Portales Brown Early Childhood Center, Project #S20-008, PSFSA FUNDING

**APPROVED MECHANICAL**  
**TAMARA KUYKENDALL**  
Exceptions As Noted  
Checking is only for general conformance with the design concept of the plans and general compliance with the information given in the contract documents. Any omissions or corrections are subject to the requirements of the plans and specifications. Contractor is responsible for dimensions, materials and workmanship and compliance with the applicable codes and regulations. All work shall conform with the Uniform Mechanical Code and Plumbing Codes, any other applicable codes and the requirements of the Mechanical and Plumbing codes.  
02/28/2020 9:47:29 AM

**ELECTRICAL APPROVED - Kelly Larsen**  
Exceptions As Noted  
Checking is only for general conformance with the design concept of the plans and general compliance with the information given in the contract documents. Any omissions or corrections are subject to the requirements of the plans and specifications. Contractor is responsible for dimensions, materials and workmanship and compliance with the applicable codes and regulations. All work shall conform with the Uniform Electrical Code

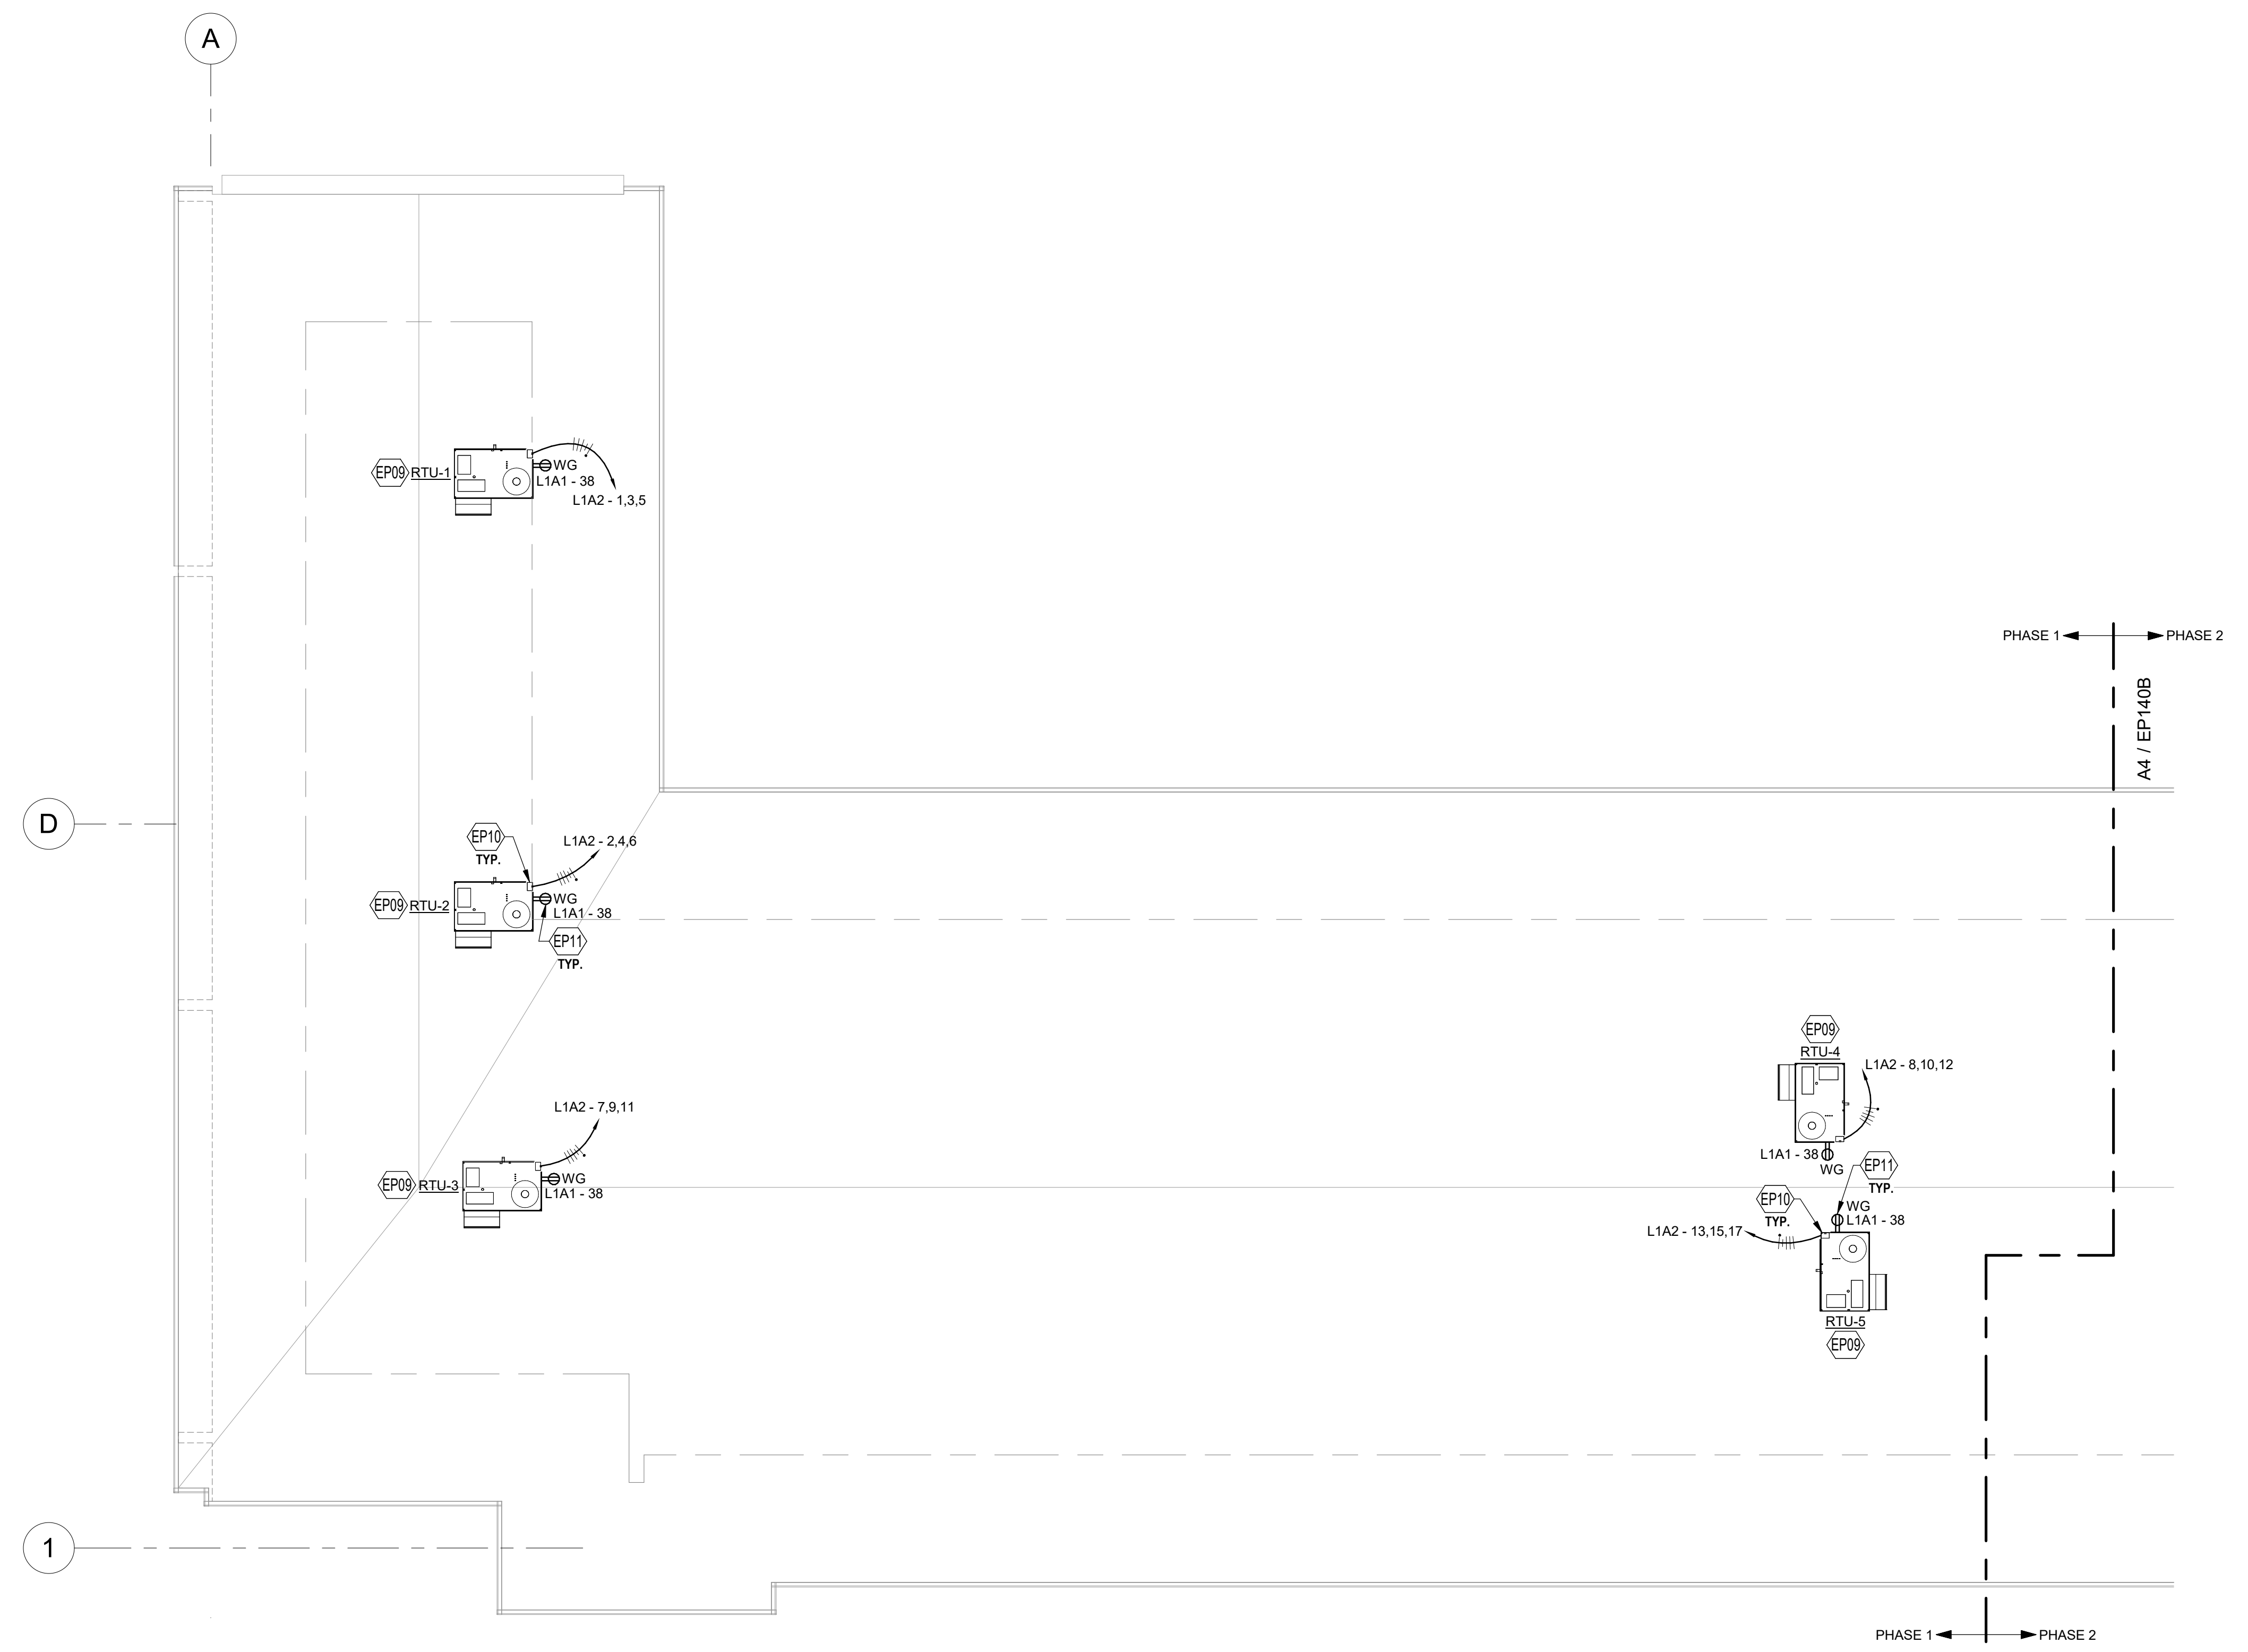
NMEC 250.118(15) - Equipment Grounding  
Conductor Required With All Branch Circuits and  
Feeders On or Above Roofs
